HISTORIC LANDMARK COMMISSION
APPLICATION FOR A CERTIFICATE OF APPROPRIATENESS
APRIL 22, 2019
C14H-1974-0028
MOONLIGHT TOWERS
VARIOUS LOCATIONS

Restore nine Moonlight Towers and reconstitute three Moonlight Towers, including use of replacement leg and horizontal members as needed with milled steel parts.

As viewed from 6 feet away: Square tubes (left); original tower section (right)

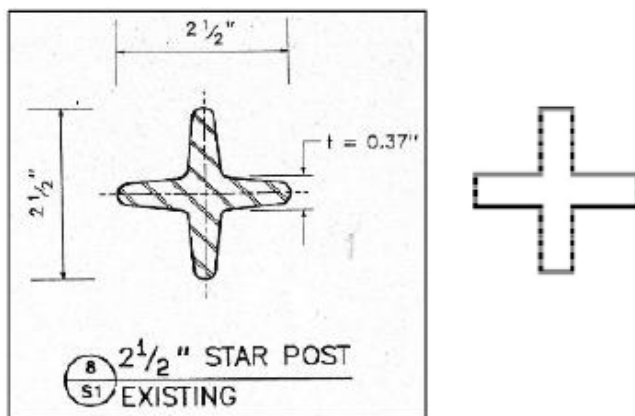
The proposed project will preserve the historic character of the Moonlight Towers and retain their distinctive features, spaces, and spatial relationships. Though the milled members have a slightly different profile than the originally cast star posts, the two appear to be identical from six feet away, and most of the towers are viewed from a much greater distance.

Approve the proposal for milled replacement members; authorize staff to administratively approve a strategy for tower restoration and reconstitution.
